Staff Report

To: Planning & Zoning Commission
 From: Planning Staff
 Report: September 11, 2020 – **AMENDED 9/14 & 9/15 WITH ADDITIONAL PUBLIC COMMENTS ATTACHED**
 Meeting: September 15, 2020
 Item: PS20-0003: University Park Subdivision

Applicant:	Tim McDonnell K-M Enterprises of Idaho LLC & Derek Mulgrew M & W Holdings LLC
Requested Action:	Take Public Testimony and recommend approval/denial to the City Council
Purpose:	To subdivide a site totaling 75-acres into 152 lots.
Location:	Existing structure on northern parcel: 1904 N Boyer Ave. Parcel No. RPS00000150751A & RPS00000151250A. Site bounded by E. Mountain View to the north, N. Boyer Ave. to the west, Sand Creek and 5th Ave to the east, and BNSF Railway tracks to the south.
Size:	Total is approximately 75 acres Lots proposed: 152 total. Lots range from 5,100 sf to 12.3 acres in size.
Existing Zoning & Context Area:	Zone: Residential Single-family (RS) and Commercial B (CB) Context Area: CA-3, CA-3B, CA-4, Park
Surrounding Land Use and Zoning:	<u>North:</u> Single family homes (RS) <u>South:</u> Industrial/Commercial uses (IBP, IG, and CB) <u>East:</u> Railroad right-of-way, Sand Creek, City Limits <u>West:</u> Single family

Figure 1 – Site Location

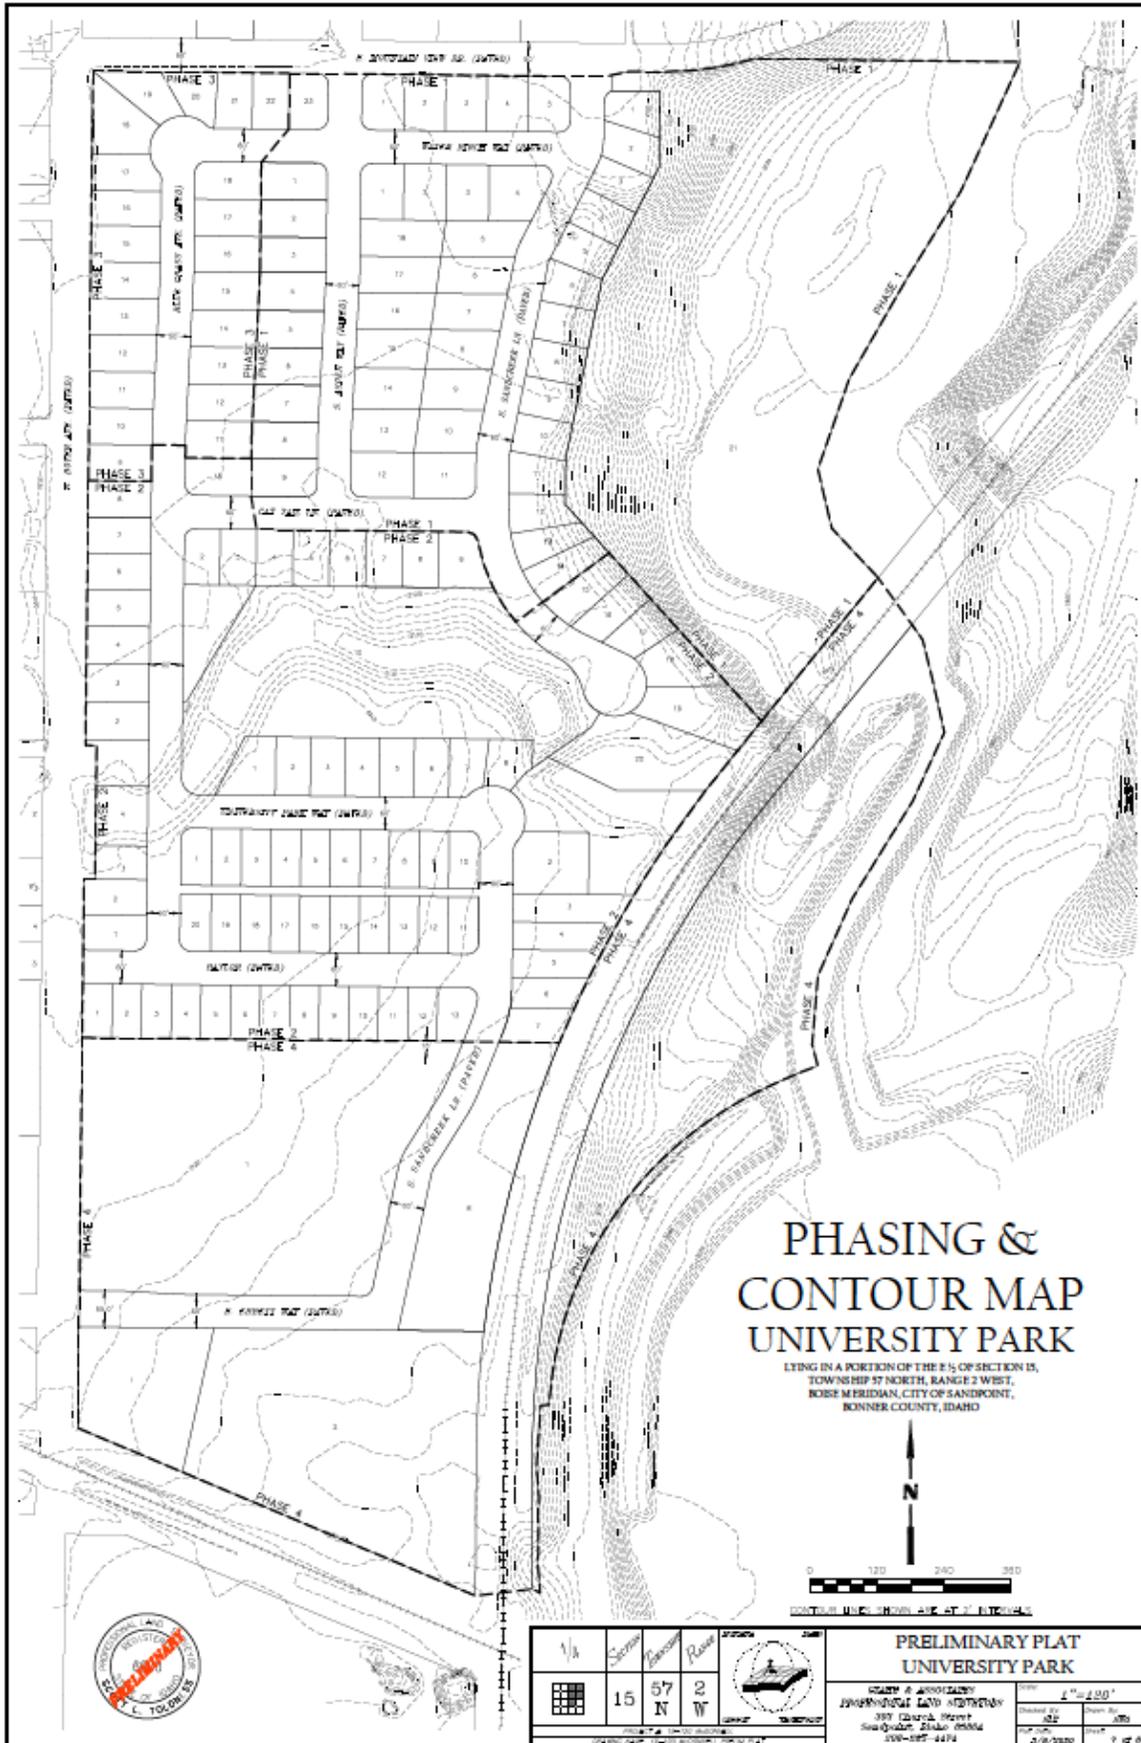
The applicant is proposing to subdivide an approximately 75-acre predominantly Residential Single-Family zoned site (Figure 1) into 152 lots (Figure 2). That portion of the site east of the railroad tracks is zoned Commercial B which is retained as a single lot. The resulting lots to the west meet the Residential-Single Family (RS) zoning minimum lot size standards (5000 square feet) and frontage standards (50' along public road) as required by City Code §9-4-1-3.
